Access Compliance Report

Public Rights-of-Way

Intersection ID: N/A	Main Street: PROVIDENCE_RD	Cross Street: PROVIDENCE_CHURCH_LN	Location: SW
ADA ID: 7510454F60C4	Ramp Type: Perp	Initial Pass/Fail: Fail	Overall Compliance: No
Codes/Mitigation Info/Possible Solution		Field Measurements/Component Compliance

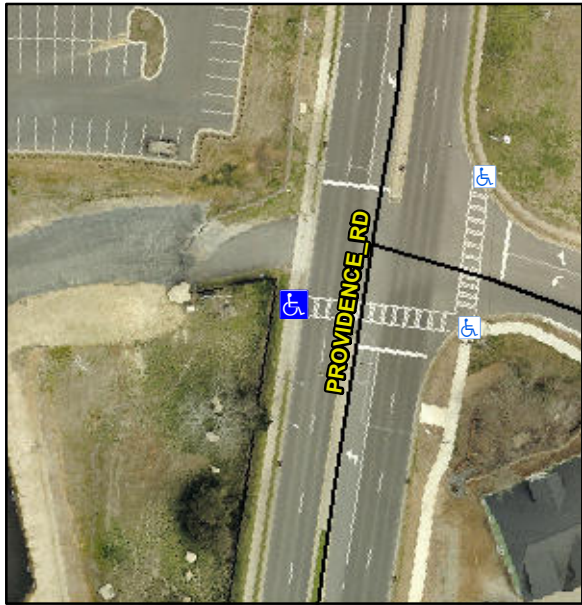
Not Found, R304.2.2

Compliance	Description	Data	Compliance	Description	Data
N/A	Ramp Length (in)	24.0	No	Ramp Slope (%)	14.9
Yes	Ramp Width (in)	110.0	Yes	Ramp XSlope (%)	2.5
N/A	Flare Type LT	N/A	N/A	Flare Type RT	N/A
N/A	Flare Slope LT (%)	N/A	N/A	Flare Slope RT (%)	N/A
N/A	Flare Traversable LT?	N/A	N/A	Flare Traversable RT?	N/A
N/A	Landing Length (in)	N/A	N/A	DWS Provided?	N/A
N/A	Landing Width (in)	N/A	N/A	DWS Contrast?	N/A
N/A	Landing Slope (%)	N/A	N/A	DWS Length (in)	N/A
N/A	Landing X Slope (%)	N/A	N/A	DWS Full Width?	N/A
N/A	Landing Curb? (Y/N)	N/A	N/A	DWS Offset (in)	N/A
N/A	Shared Landing?	N/A			
N/A	Gutter Ponding?	N/A	N/A	Gutter Slope (%)	N/A
N/A	Gutter Lip Ht (in)	N/A	N/A	Gutter X Slope (%)	N/A
N/A	Painted X Walk1?	Yes	N/A	Painted X Walk2?	N/A
	X Walk 1 Direction	To SE		X Walk 2 Direction	N/A
N/A	X Walk 1 Width (in)	111.0	N/A	X Walk 2 Width (in)	N/A
	X Walk 1 Slope (%)	1.6		X Walk 2 Slope (%)	N/A
	X Walk 1 X Slope (%)	3.9		X Walk 2 X Slope (%)	N/A

Remove & Replace Entire Ramp.
